Sinclair College
Building 14 – EMS Classrooms & Sim Lab
FAC 24-28X
Dayton, OH

ADDENDUM 01

Date of Addendum: January 31, 2025

This addendum consists of five (5) pages plus attachments.

1 CLASSROOM AV SYSTEM - SIM LAB
SCALE: 3" = 1'-0"

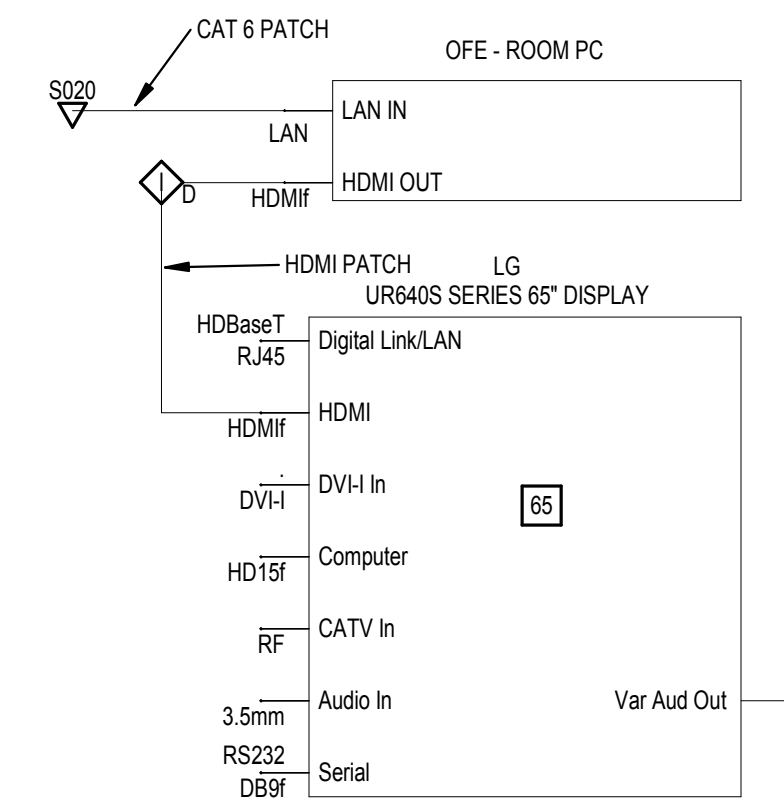
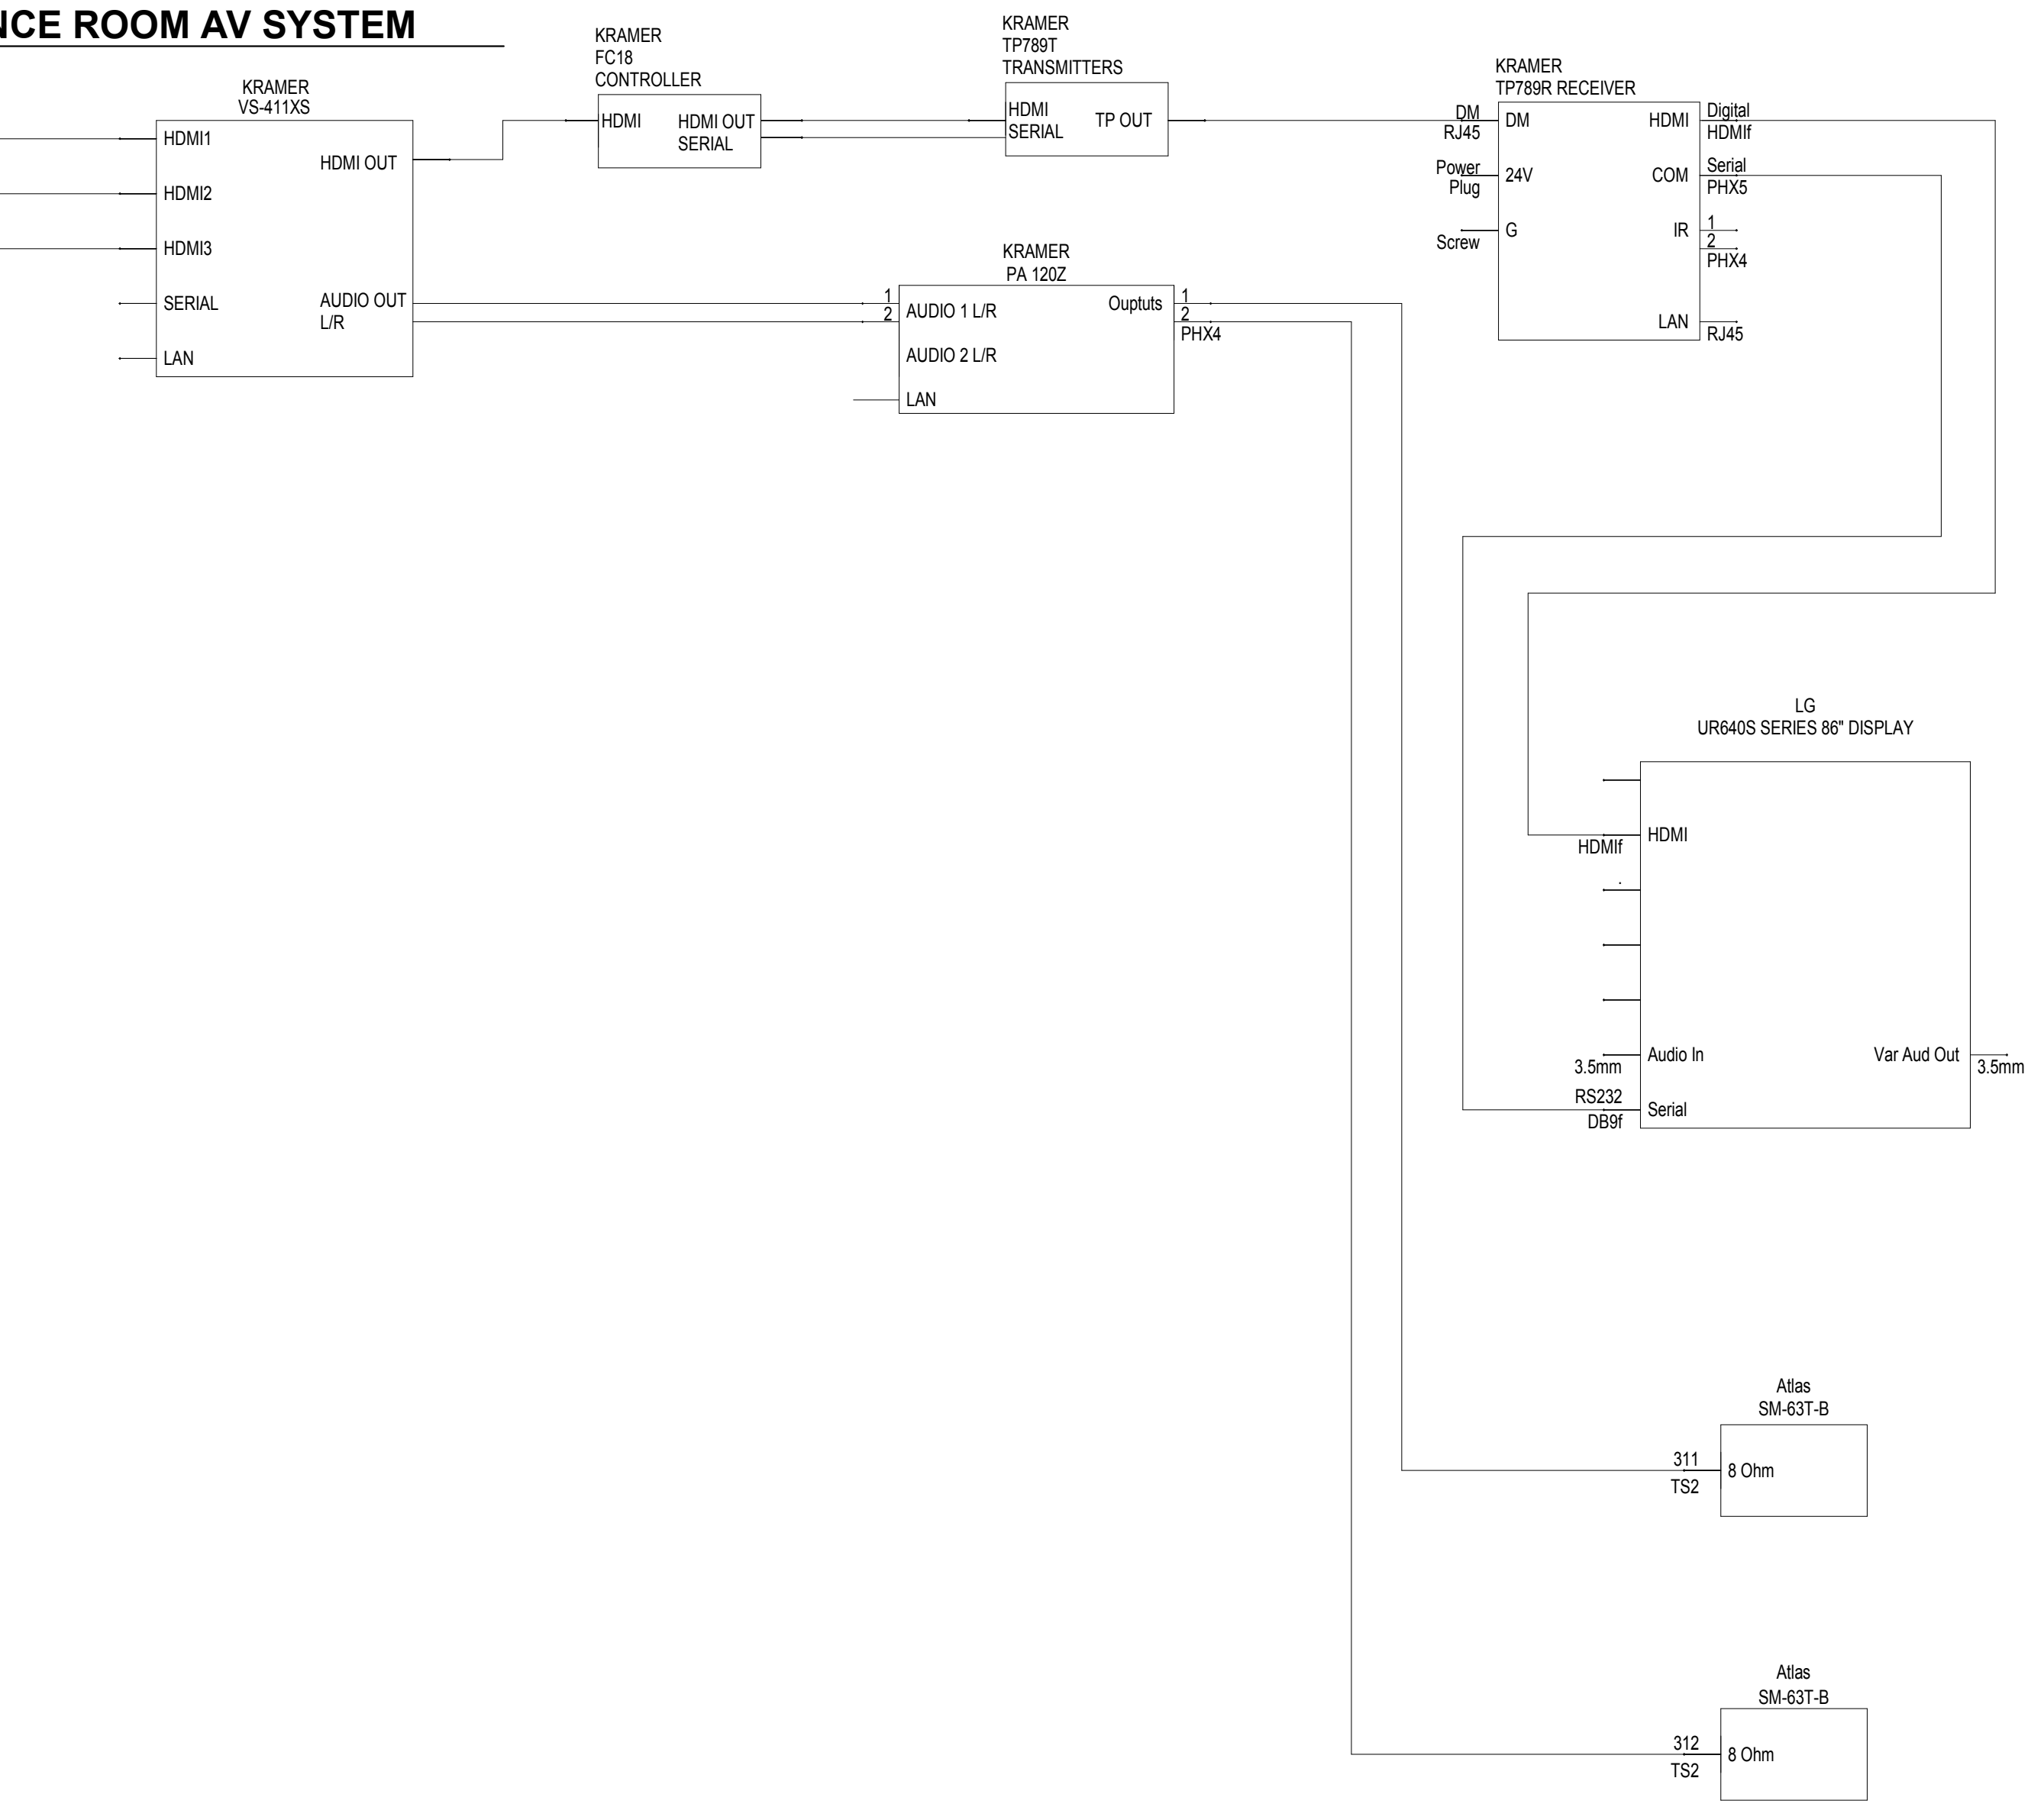
12. Sheet T003 AV SYSTEM DETAIL

- a. Add note to instructor input outlet to provide 2-gang engraved plate.

1 CLASSROOM AV SYSTEM - LECTURE HALL 01
 SCALE: 3" = 1'-0"

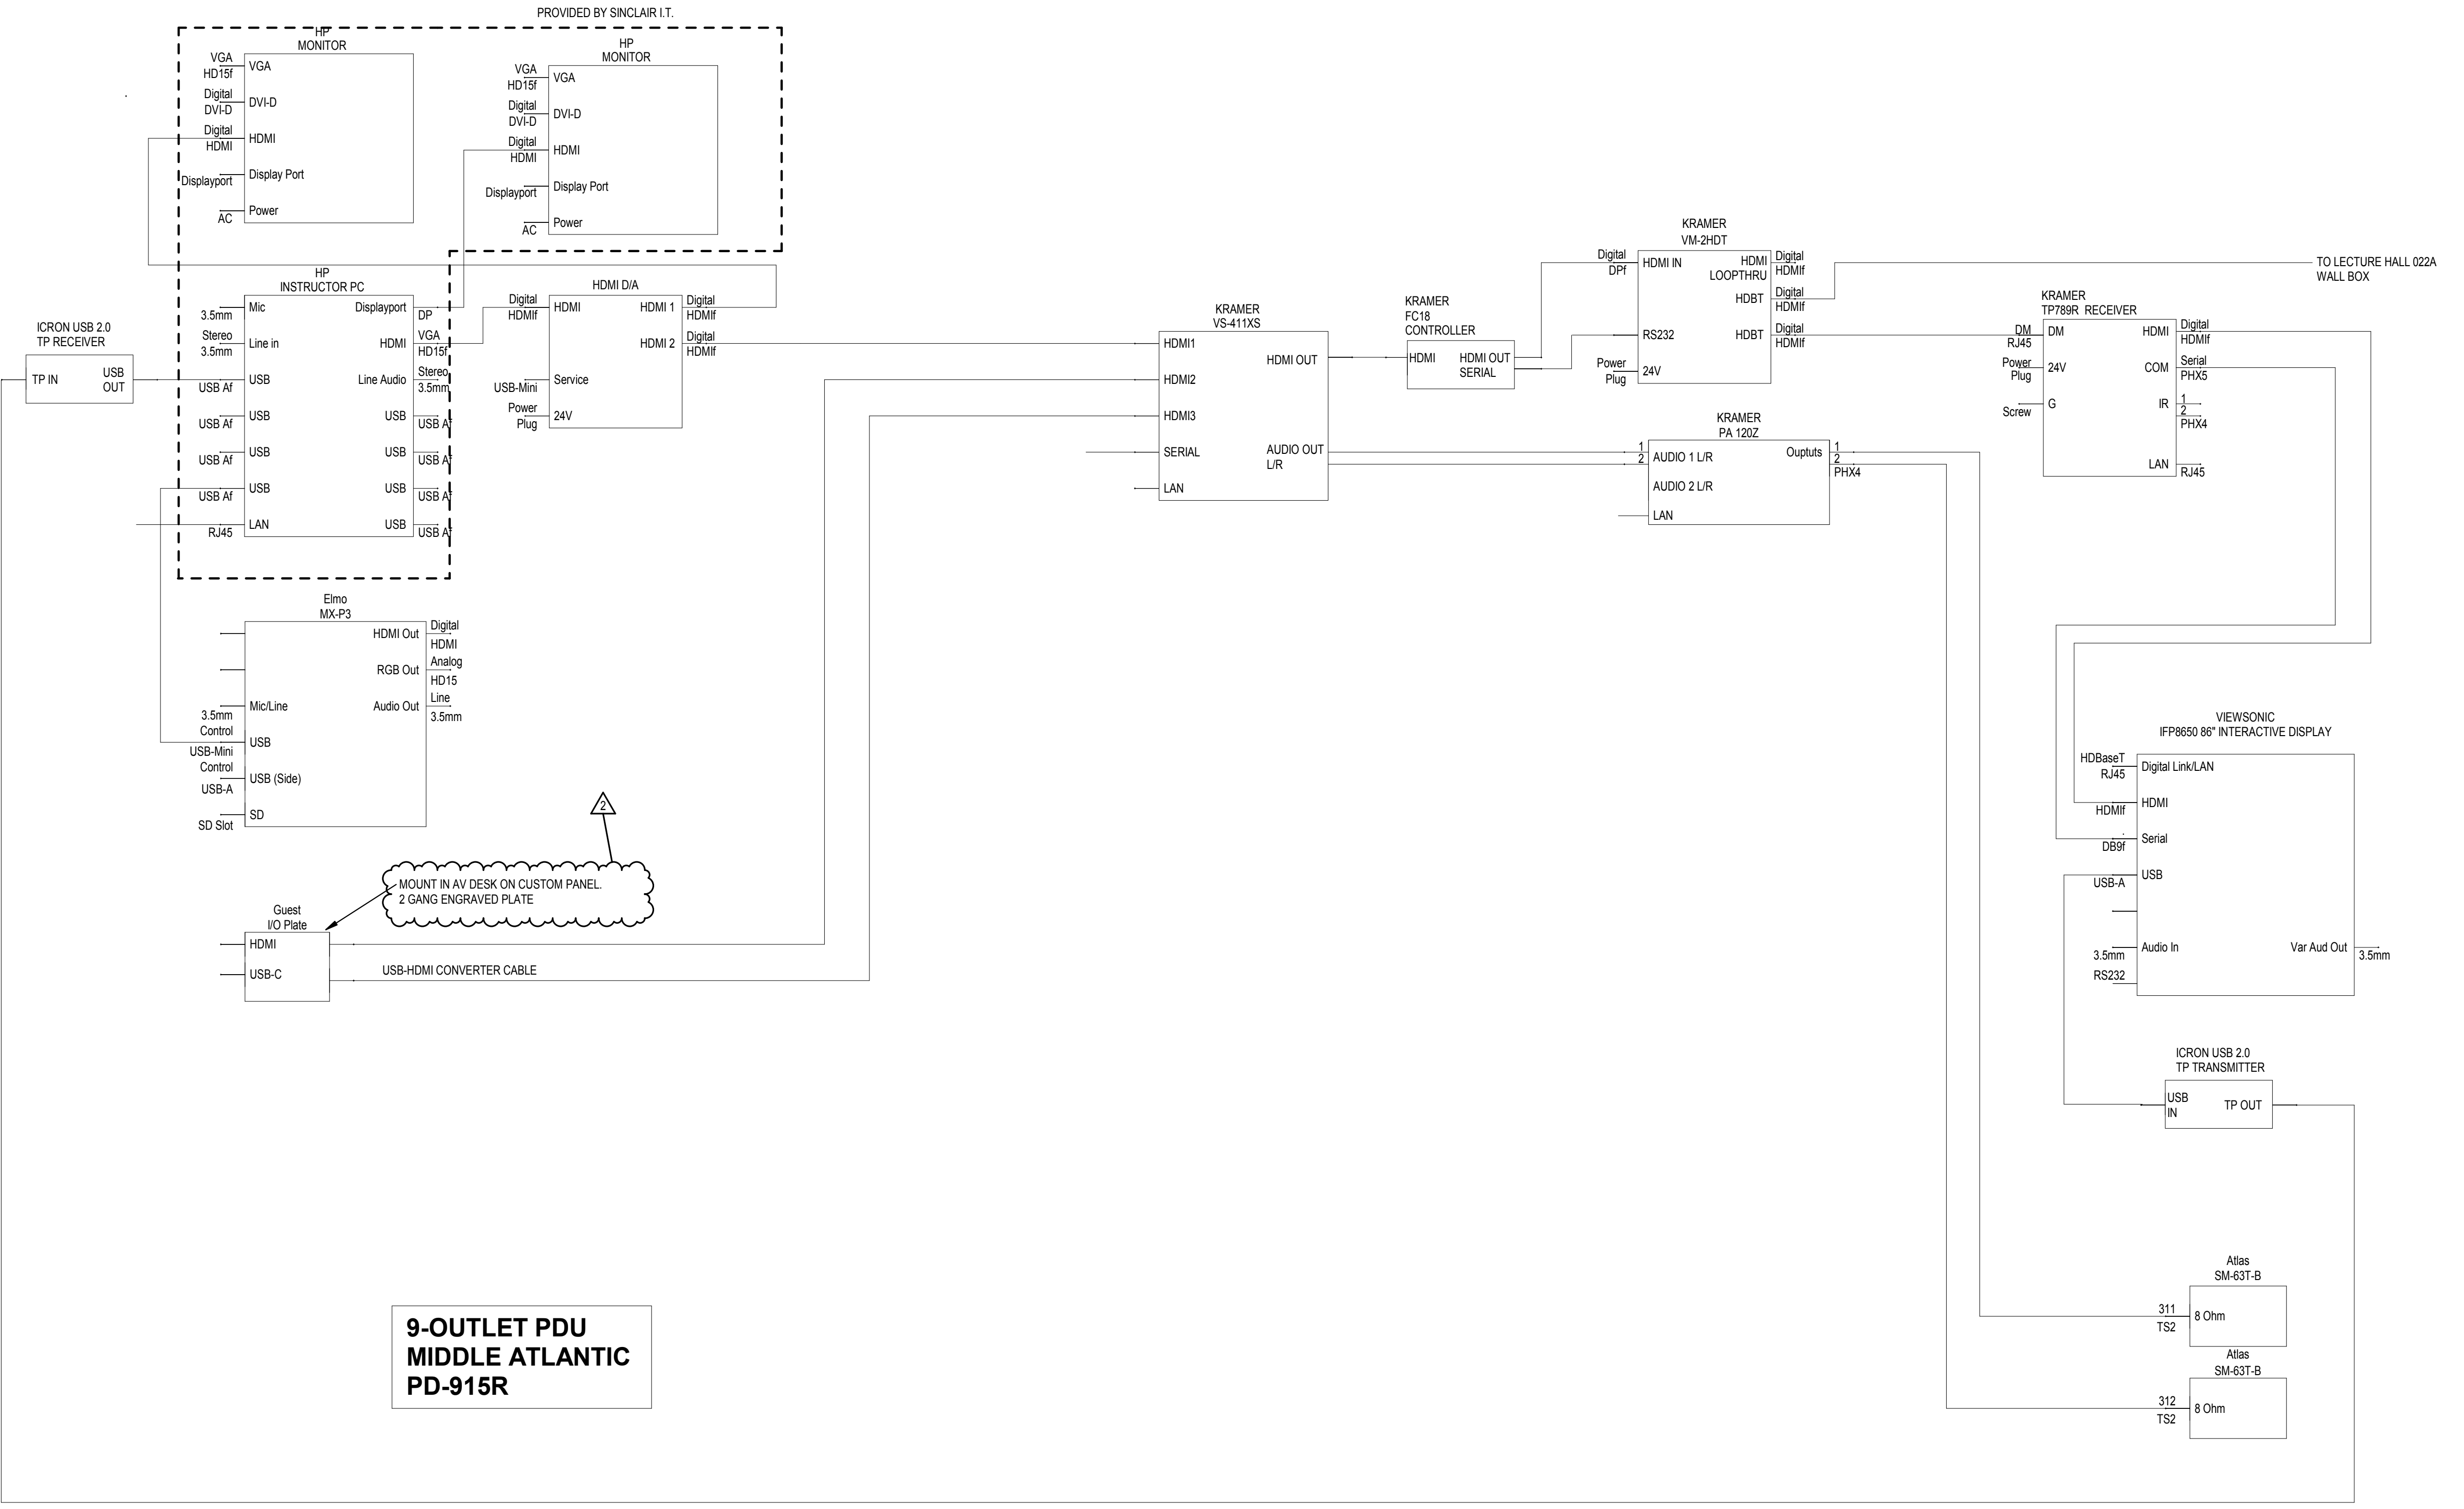
13. Sheet T004 AV SYSTEM DETAIL

- a. Add note to instructor input outlet to provide 2-gang engraved plate.
